MINUTES
BROOKSHIRE-KATY DRAINAGE DISTRICT

Reference: Sunterra Phase V – Drainage Impact Assessment
Land Tejas 2,303 Acre Tract - Sunterra
Waller County, Texas
Quiddity Job No. R0002-1004-06

Subject: Drainage Impact Analysis for Sunterra Phase V
County: Fort Bend

Re: Drainage Impact Assessment
Sunterra Phase V

Figure 3: Atlas 14 100-Year Flow and Stage Hydrographs of Cane Island Branch Immediately D/S of Clay Road

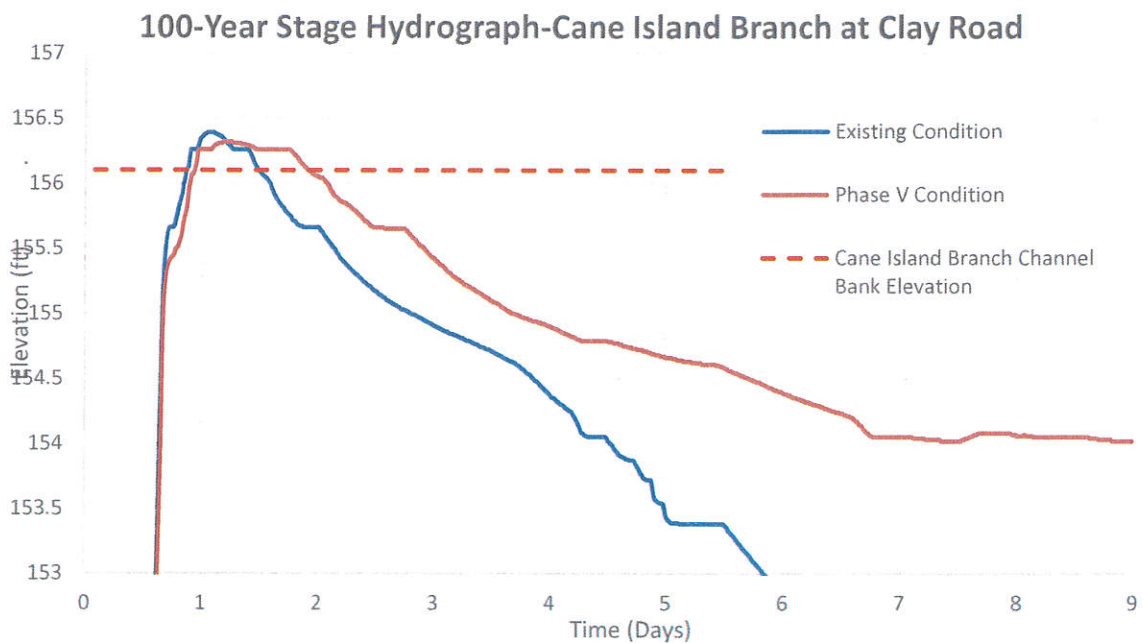
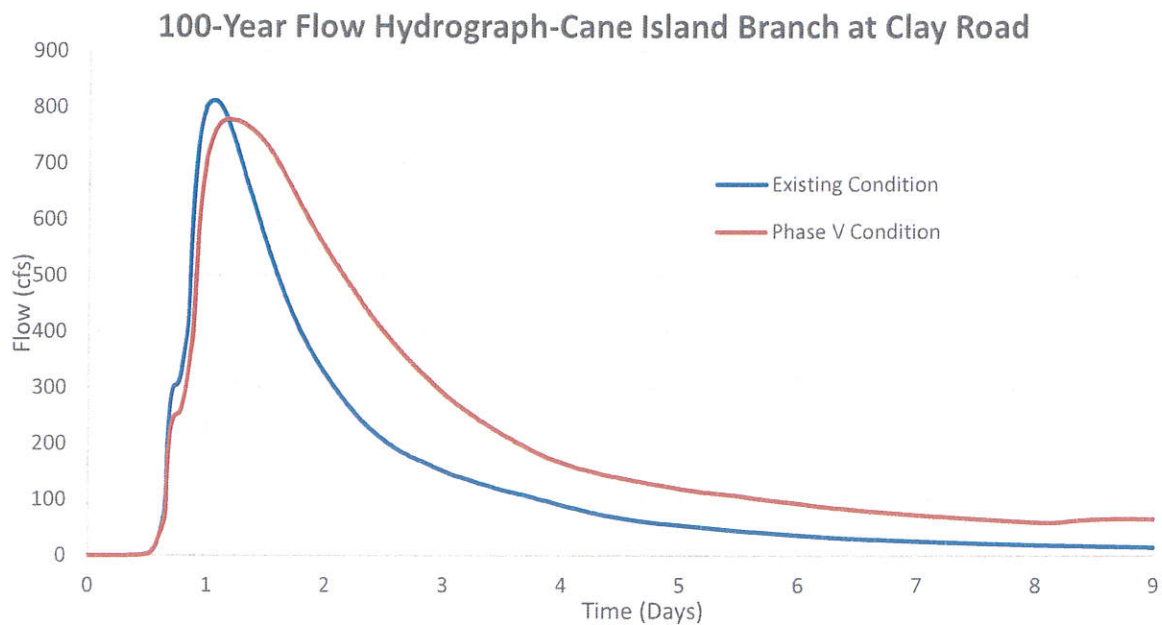
4. **Report Tables and Figures:** Peak flows and WSE do not appear to match CIB-7 from Table 6 for the Atlas 14 100-yr condition. Please provide reasoning.

Quiddity Response: The peak flows listed in Table 6 were taken from the old effective steady state model while the peak flows in Figure 3 are from the models included in this submittal. Because this is not a good comparison the peak flow comparison has been removed from Table 6.

EXHIBIT-2:
PHASE V
DRAINAGE 1,039 ac. TRACT
ANALYSIS-(100-Year)

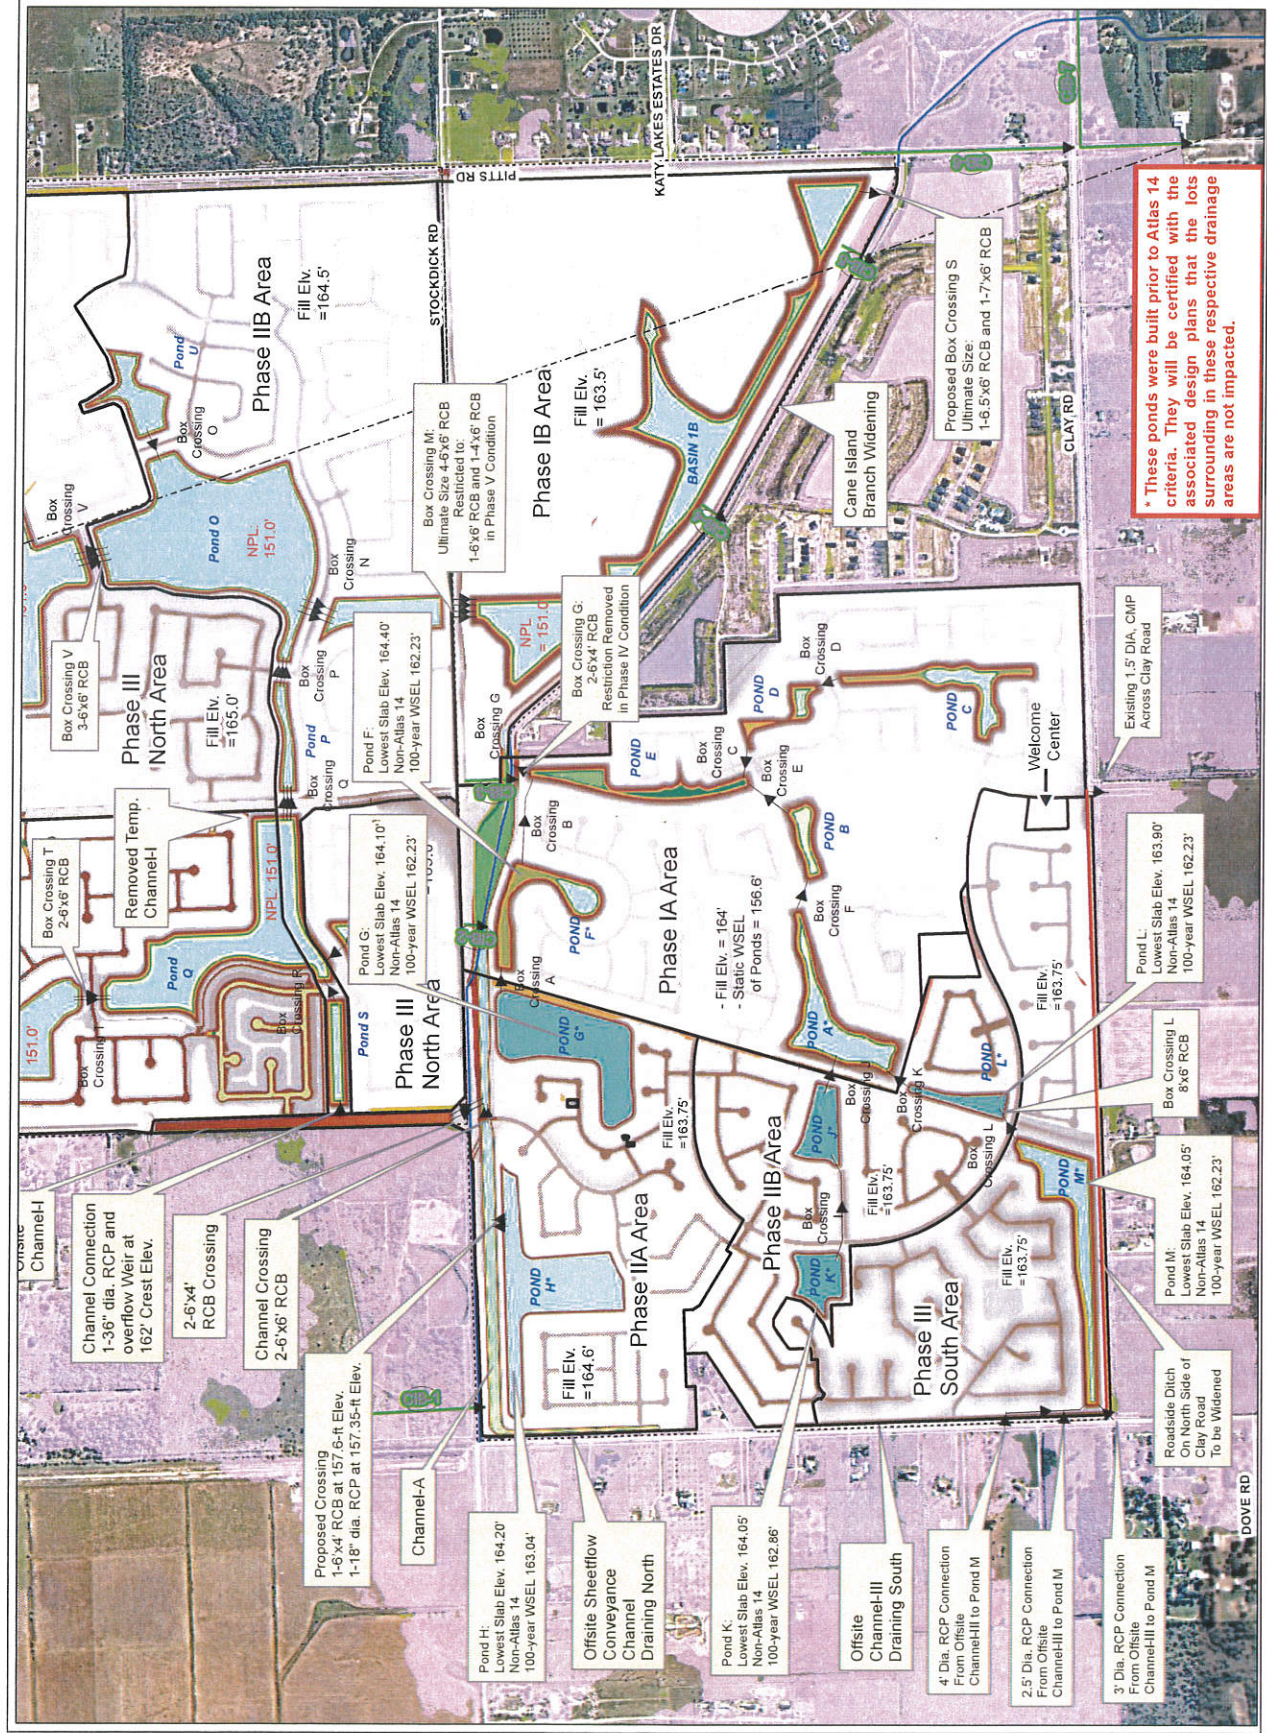
5. **Report Exhibits:** Is the Phase IV Area meant to be shaded dark gray? MG appears to be similar to Ph. V area.

Quiddity Response: The shading scale of proposed mass grading was only accurate for the mass grading for Phase V. The mass grading raster files have been combined into a single file so that the mass grading elevation scale is accurate for all grading shown. Because of this Exhibits 1 look slightly different but no elevations have changed.
